Addendum 3 for RFB927940-04

Project Name: WRC Decentralization Phase 4 & Fire Alarm Phase 3 (9279.40 & 9279.41) Bid Issuance #4
DAS RFB #: 927940-04
DAS Project #: 9279.40 & 9279.41
Date: 6/2/2026

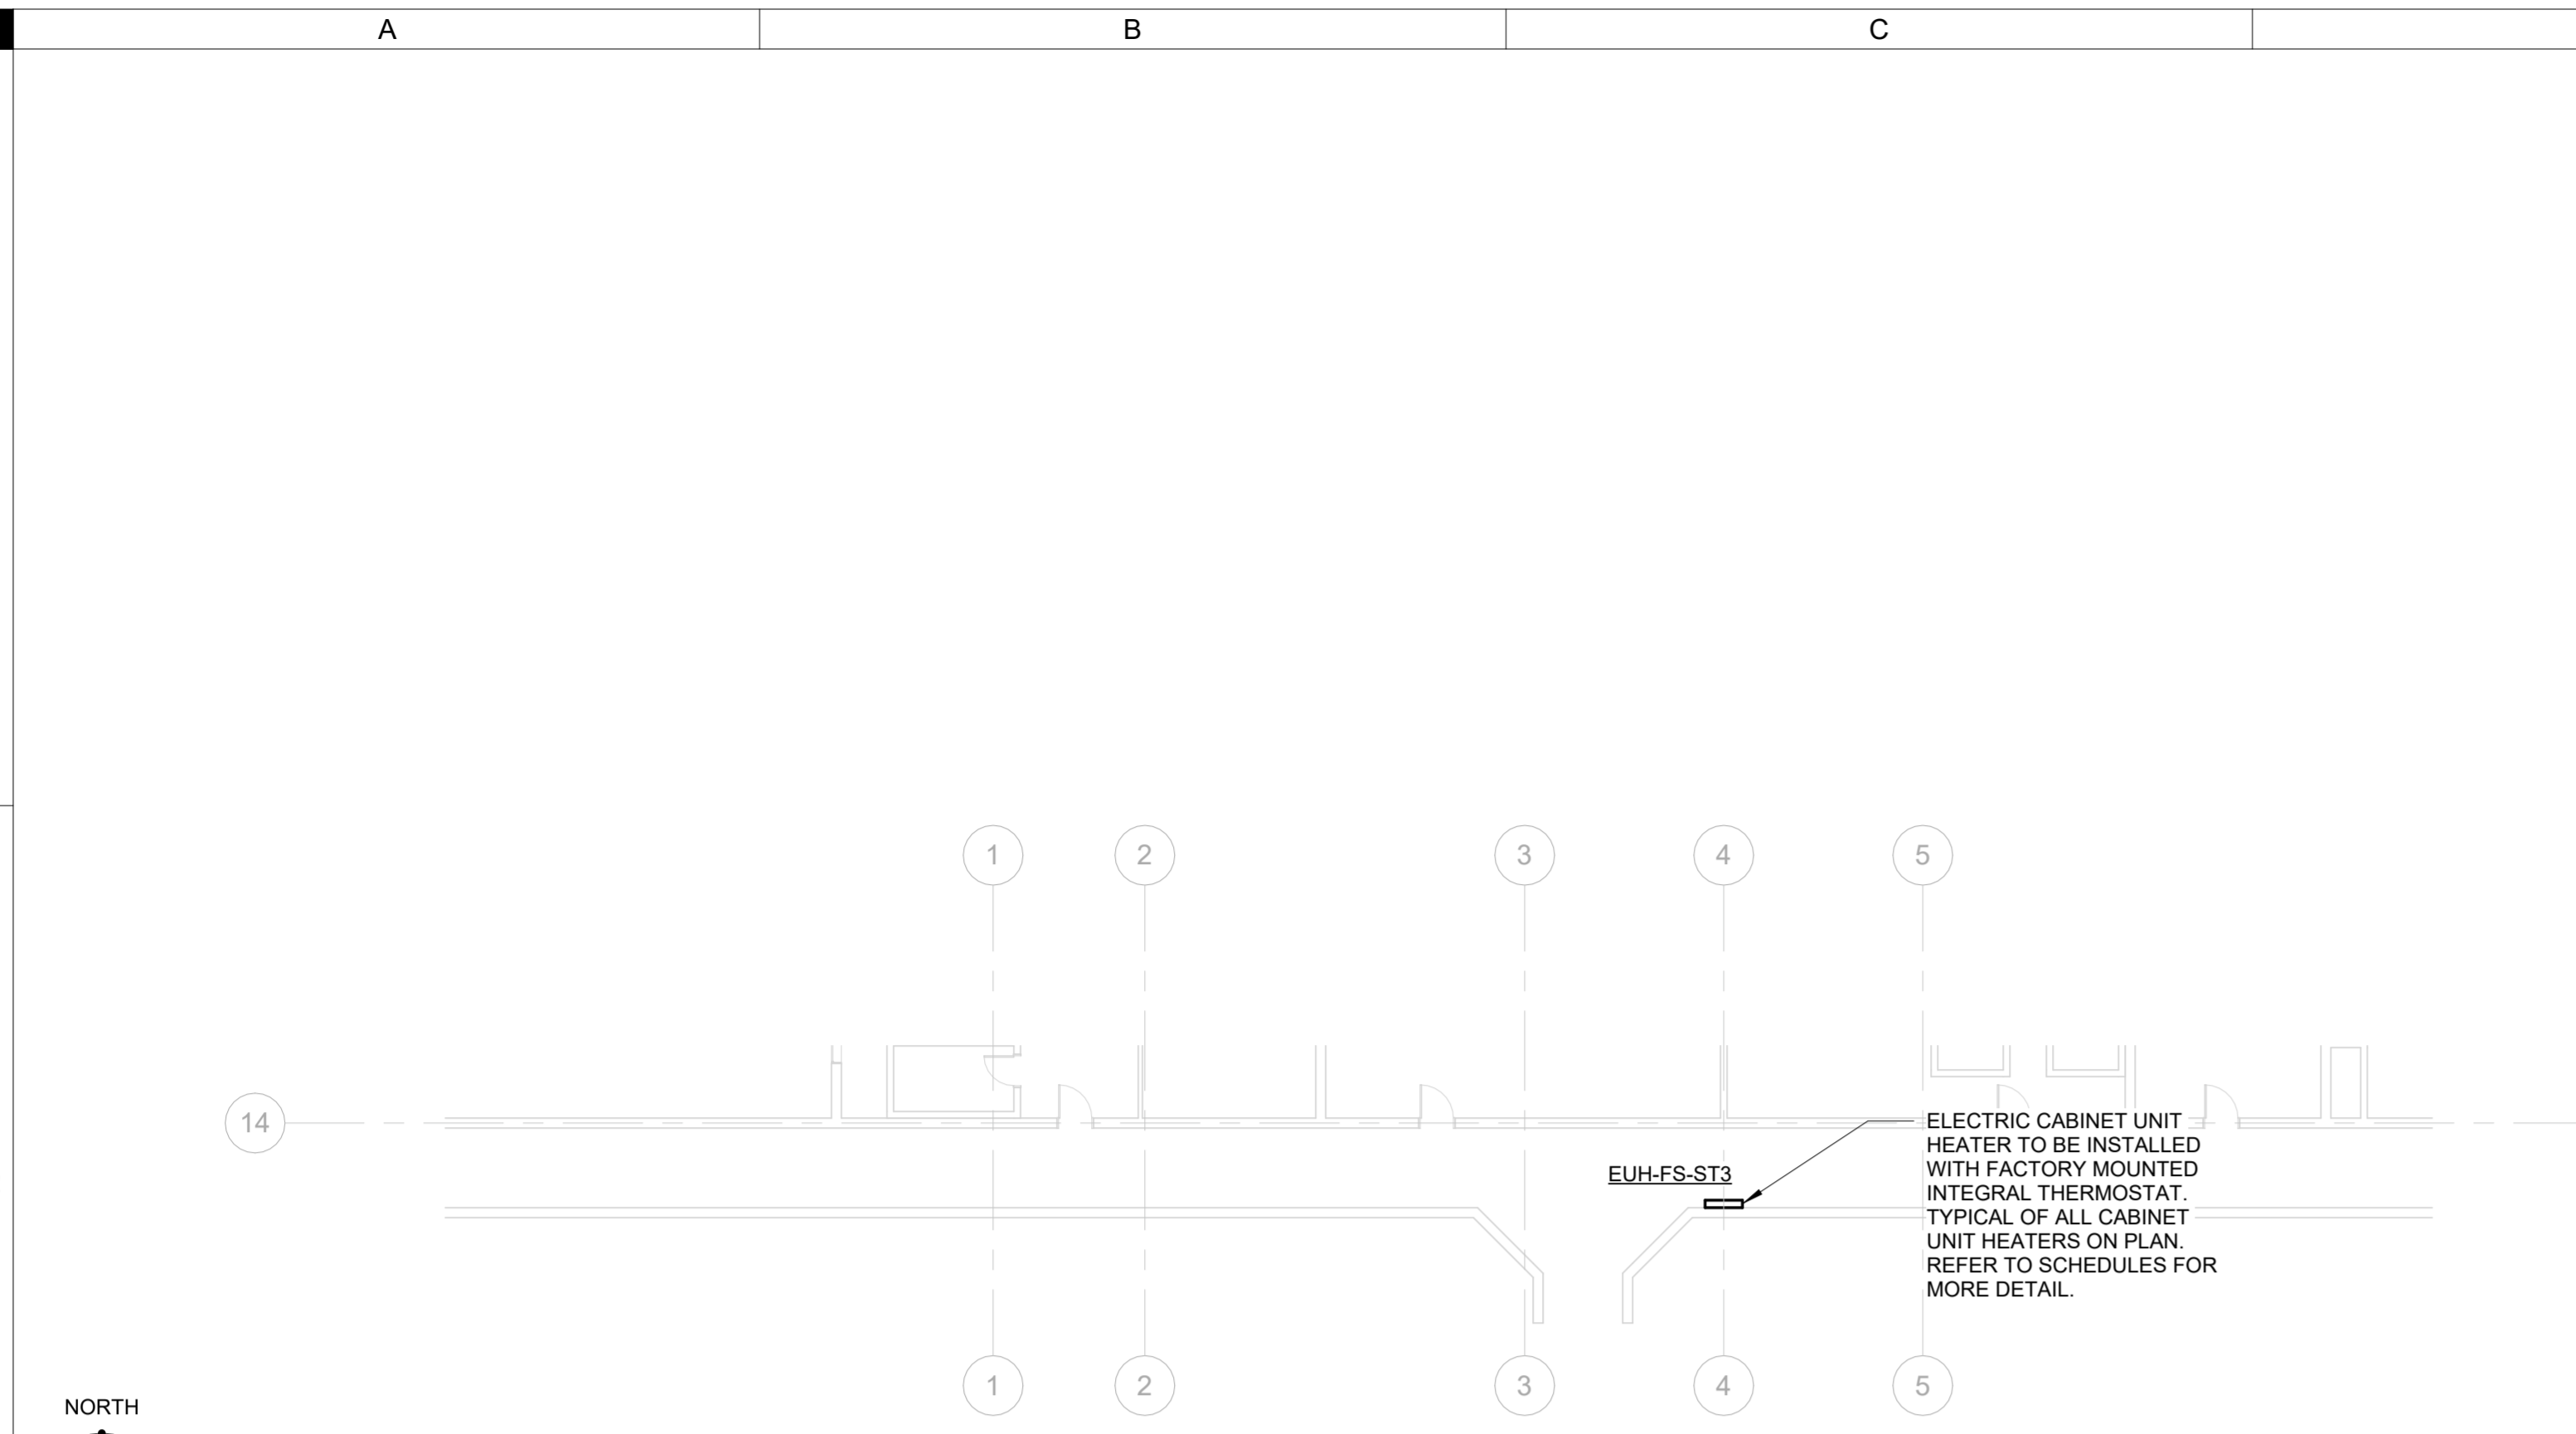
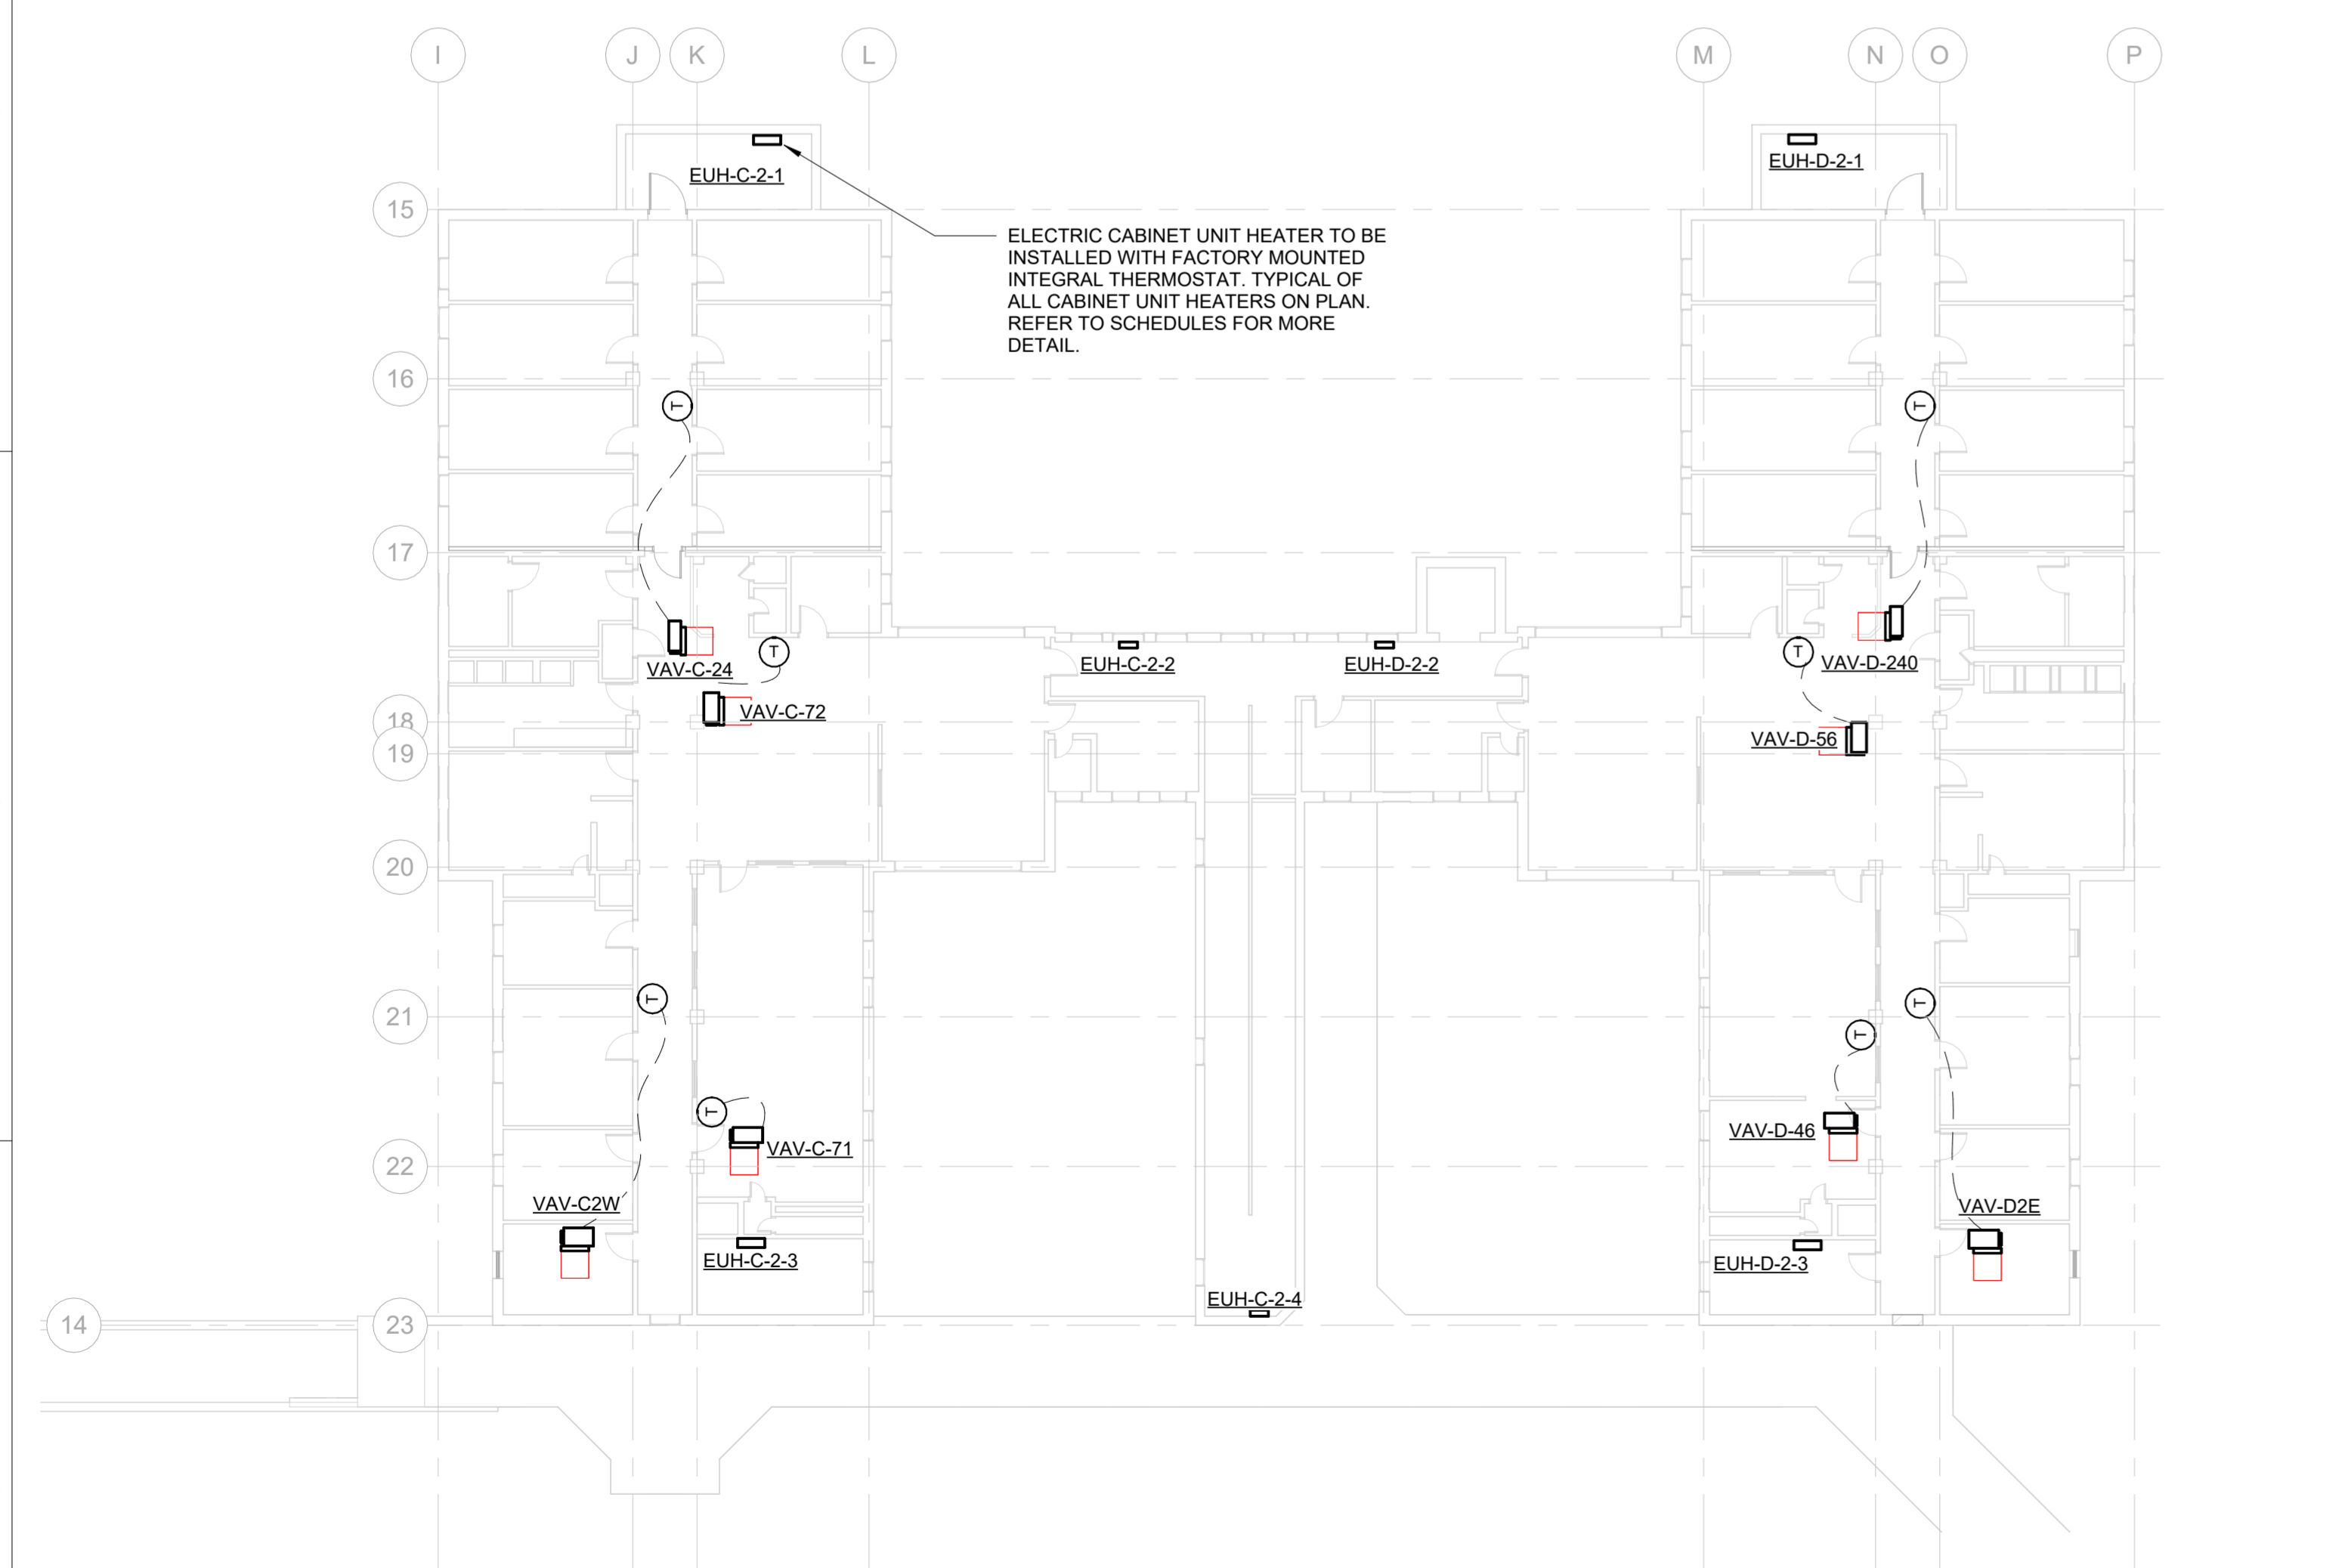
- **13-M300 – THERMOSTAT PLAN:**
 - **ADD** Tags to EUH-D-2 and ACCU-D-2.
- **13-M400 – BUILDING C & D ENLARGED AHU PLANS:**
 - **ADD** Approximate duct support locations to exterior ductwork and associated note “SUPPORTS REPRESENTATIVE OF APPROXIMATE REQUIRED SUPPORTING DISTANCE REQUIREMENTS AND QUANTITY. CONTRACTOR SHALL VERIFY SUPPORTING REQUIREMENTS WITH FINAL DUCT SIZES AND SMACNA GUIDELINES. CONTRACTOR SHALL COORDINATE LOCATIONS OF SUPPORTS WITH ALL UNDERGROUND UTILITIES AND VERIFY ALL EXISTING CONDITIONS PRIOR TO EXCAVATION AND CONSTRUCTION.”
